THIS DRAWING IS FOR
BUILDING REGULATIONS
PURPOSES ONLY

BUILDING REGULATIONS QUERIES:
**(refer to 'Approved Inspectors Ltd' correspondence of 11/0/4/22
- Reference: AIC-22-64341-RRO)**

Site: Aunt Marys Day Nursery Taylor Street Heywood. OL10 1EF	
Project: Ground Floor Entrance extension / internal alterations / partial re-build of external walls / first floor extension / external works to form additional covered play areas	
Drawing Title: Proposed Sections A-A, B-B & C-C, First Floor Detail & Construction Notes	
Date: 18/03/22	Scale: 1:50 / 1:5 @ A1
Drawing Number: LM-01/08	Revision: F

First Floor Detail - 'GypFloor Silent' (1:5 @ A1)

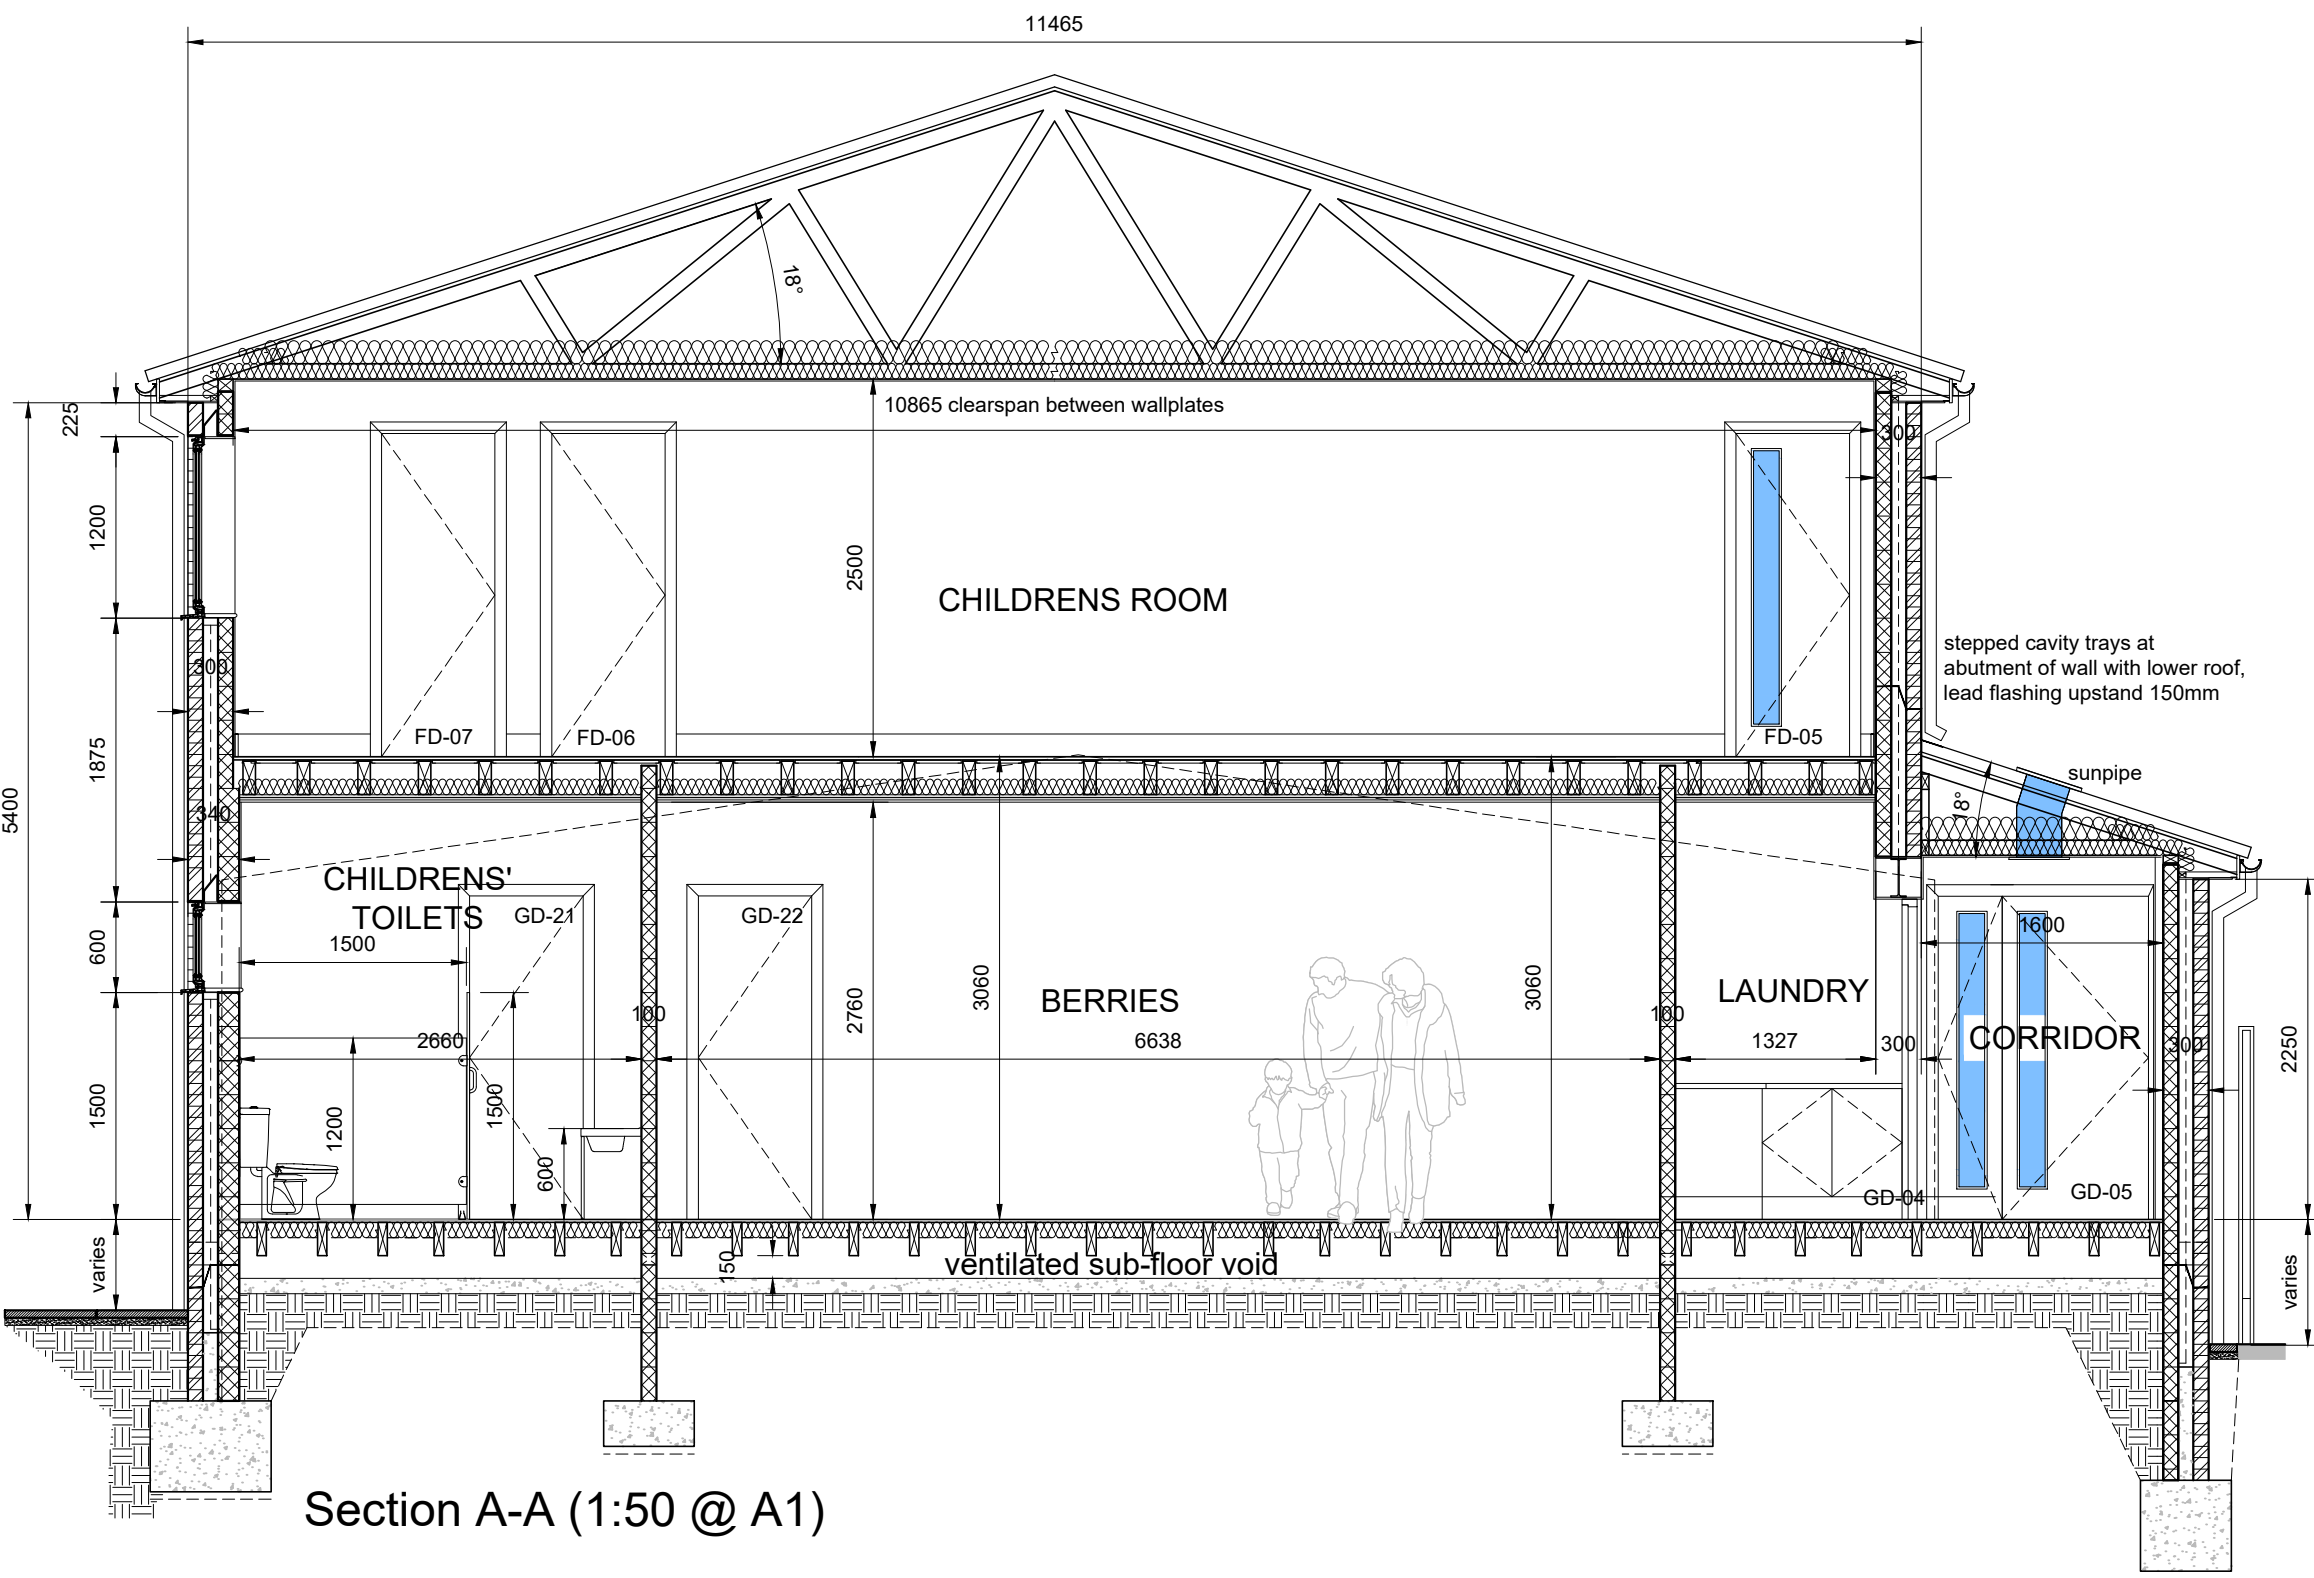
- 1 19mm Gyproc plasterboard cut to fit between floor channels with
3mm gap to vertical flange of floor channel
- 2 Minimum 2mm chipboard or softwood flooring fixed through
plasterboard to one side of channel with GypFloor SIF5 Floor
Screws

- 3 100mm Isover insulation
- 4 Timber joist width less than 64mm
- 5 Gyproframe SIF1 Floor Channel located centrally on joist
- 6 Gyproframe SIF2 Floor Channel in place of SIF1 where joist
is within 30mm of wall

- 7 Gyproframe RB1 Resilient Bars at max. 450mm centres fixed to
each joist with suitable British Gypsum screws
- 8 Short lengths of Gyproframe RB1 Resilient Bar fixed to joist with
suitable British Gypsum screws

- 9 2 layers Gyproc plasterboard or Glasroc specialist board fixed with
suitable British Gypsum screws at 230mm centres in field of board
and 150mm centres at board ends (1 hour fire resistance required)

- 10 Indicative non-loadbearing metal stud partition
- 11 Channel suitably fixed to flooring at 600mm centres (ensure
fixings do not penetrate SIF floor channel)

- 12 Timber joist width 64-75mm
- 13 Gyproframe SIF4 Floor Channel located centrally on joist
- 14 Timber joist width greater than 75mm
- 15 Two Gyproframe SIF2 Floor Channels located on joist (width
greater than 75mm) with foam inlay cut away to facilitate overlap
(2-3mm clearance gap between channel and side of joist)
